Wiltshire Council Planning Consultation Response

ECOLOGY

Application No.: PL/2026/01153

Proposal: Discharge of conditions 7 (Lighting), 9 (SUDS), 10 (CEMP), 12 (LEMP), 13 (Contamination) and 16 (Archaeology) relating to application 20/00379/OUT following Appeal Ref: 3321957.

Extract from Proposed Private Lighting Layout 1 of 2

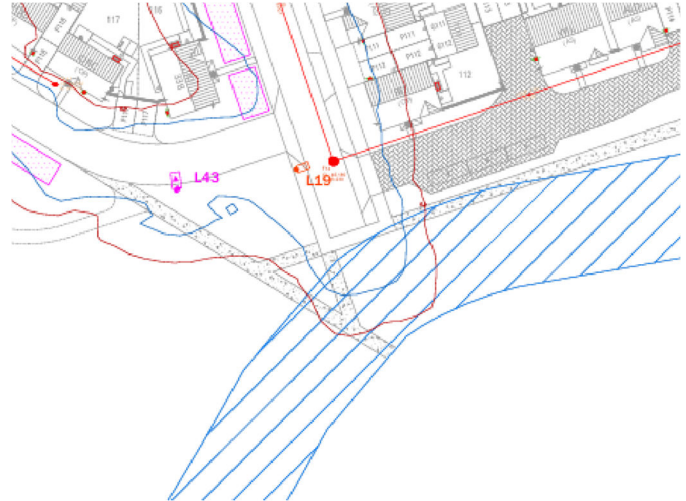
Lighting exceeds the parameters of the approved Lighting Parameters Plan (Ref. 150202) at two locations along the northern boundary and one location along the south-eastern boundary. At two of these locations (see extracts below), the elevated light levels are likely to diminish the suitability of core bat habitat for foraging and commuting bats and are therefore considered unacceptable.

Unless satisfactory evidence is provided to justify this departure from the approved Lighting Parameters Plan, the lighting strategy must be revised to comply with the approved parameters.
